November 3, 2025

Re: VARIANCE REQUEST
KINCAID PROPERTY
1031 LONDON LANE
ARNOLD, MD 21012

VARIANCE EXISTING CONDITIONS SITE PLAN

PROPOSED CONDITIONS PLAN

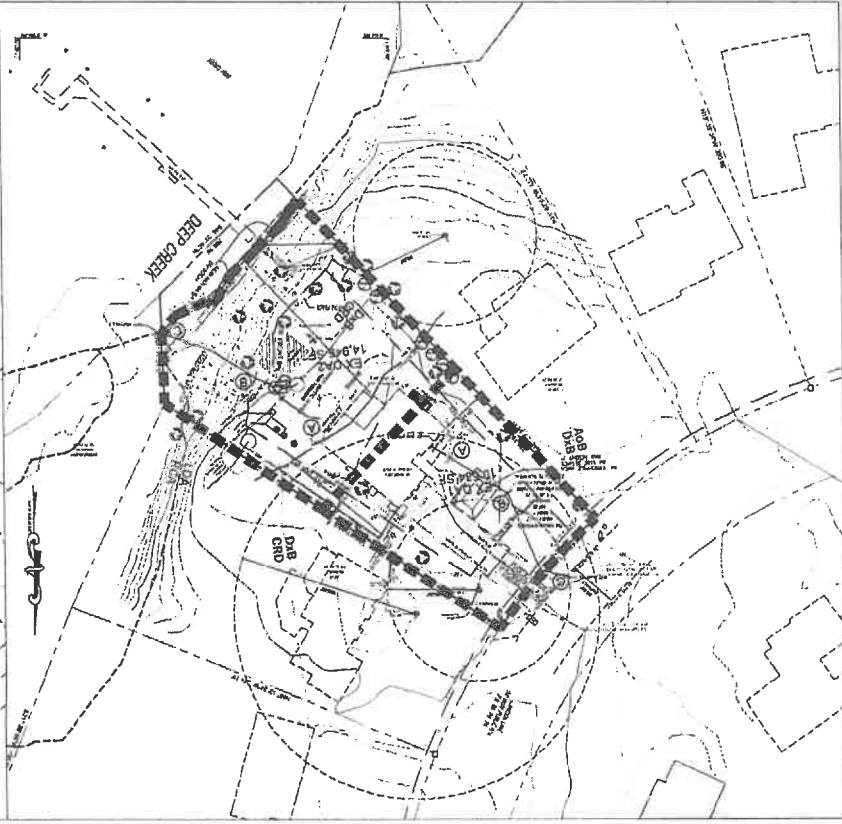
3. Label the square located directly west of the proposed house, outside of the LOD. State whether or not it is to remain or to be removed.
4. On the Proposed Conditions Plan, the LOD appears excessive, extending into the Landon Lane ROW, while the existing asphalt driveway is shown to remain. Revise as needed.

5. On the Proposed Conditions Plan, the LOD cuts through the primary drywell. Revise as needed.
6. It appears only two primary drywells are shown on the plan. If backup drywells are required by the Health Department, show and label them on the plans.

7. On the Proposed Conditions Plan, along the site's southeastern boundary with Lot 21, the LOD is shown crossing an existing wooden fence. Indicate if this fence is to remain or to be removed and revise the LOD as needed.

8. On the Proposed Conditions Plan, show the proposed grading contours even if they are in the same location as the existing grading contours.
9. On the Proposed Conditions Plan, label the existing composite deck.

10. The existing 3" tree cluster shown to be removed on the Existing Conditions Plan is shown on the Proposed Conditions Plan in the middle of the bumpout of the proposed house. Remove it from the Proposed Conditions Plan.

14. The brick stoop and stairs noted to remain on the Existing Conditions Plan is not shown on the Proposed Conditions Plan. Revise the label as needed.
